PROJECT NAME: BARRE CITY
 PROJECT NUMBER: FECC F 026-(K34) C/2
 FILE NAME: z85b010bdr_cp_C2
 PROJECT LEADER: G. BAKOS
 DESIGNED BY: D. PECK
 GENERAL PLAN #5

PLOT DATE: 3/9/2011
 DRAWN BY: D. PECK
 CHECKED BY:
 SHEET 60 OF 339

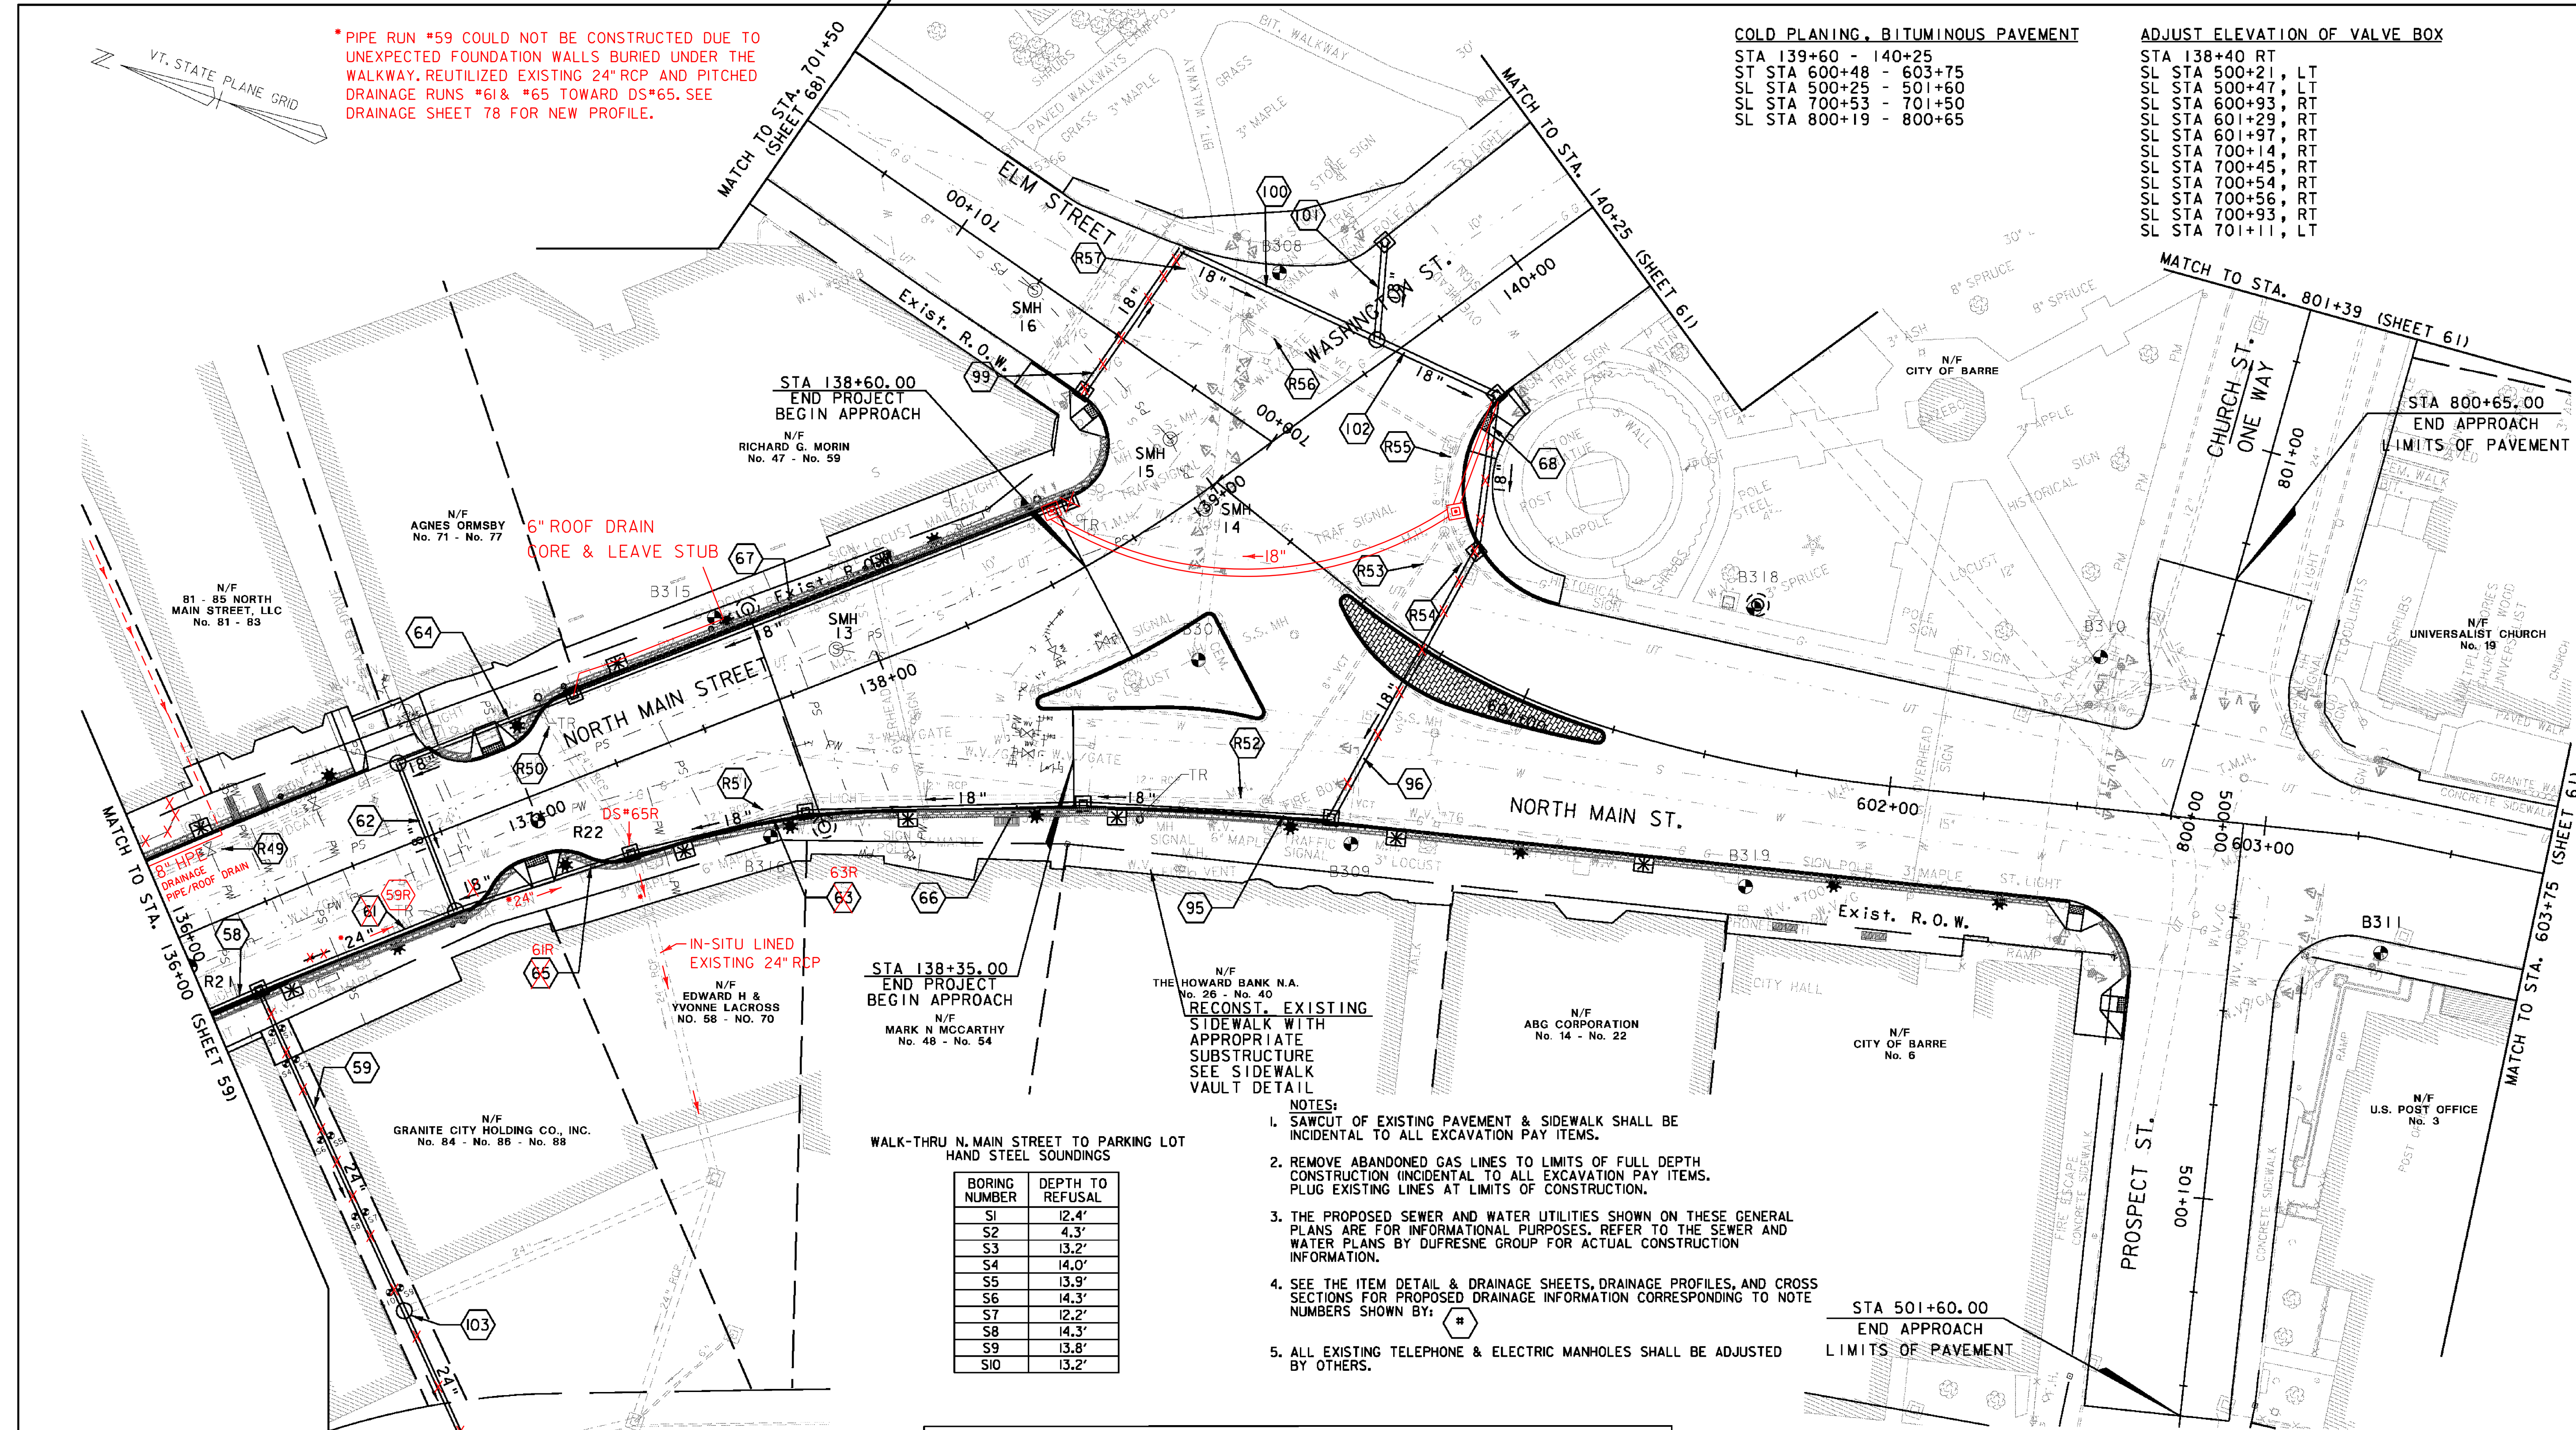
*PIPE RUN #59 COULD NOT BE CONSTRUCTED DUE TO UNEXPECTED FOUNDATION WALLS BURIED UNDER THE WALKWAY. REUTILIZED EXISTING 24" RCP AND PITCHED DRAINAGE RUNS #61 & #65 TOWARD DS#65. SEE DRAINAGE SHEET 78 FOR NEW PROFILE.
